Change Notice No.	Notification date	Implementation date
CN/19/013	August 05, 2019	September 05, 2019

Subject : Improved design of mdi Funnel (Funnel Base)

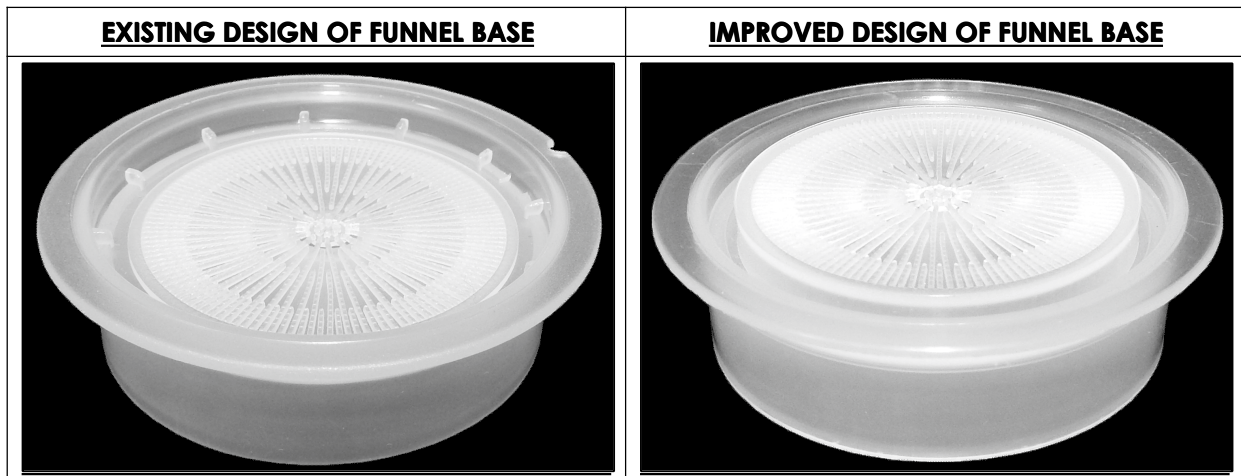
In our efforts to provide the user better products which are more convenient to use, certain changes have been made in the design of base of **mdi** Funnel with catalog numbers as mentioned above.

During use of **mdi** Funnel, the membrane is to be cultured with growth medium for incubation. To perform this process step, the membrane assembled in funnel base has to be lifted and transferred to respective growth medium plates to facilitate the growth of microorganism retained on the membrane. It was observed that It was sometimes difficult to lift the membrane from the Funnel base. To address this observation, the design of funnel base has been improved through raising the central part having flow channels (used for the assembling/fitment of membrane) for easy lifting of membrane and corresponding change has also been done in funnel cup for proper fitment with new base. The new design of **mdi** Funnel has been verified for critical product performance parameters including fitment with respective components/manifolds and flow rates. No change has been done in any other critical dimensions or materials of construction or manufacturing process of **mdi** Funnel.

From a practical point of view, the changes done will improve the use of **mdi** Funnel with regards to easy lifting of membrane. All performance specifications and product attributes will remain unchanged, except the improved design of Funnel base.
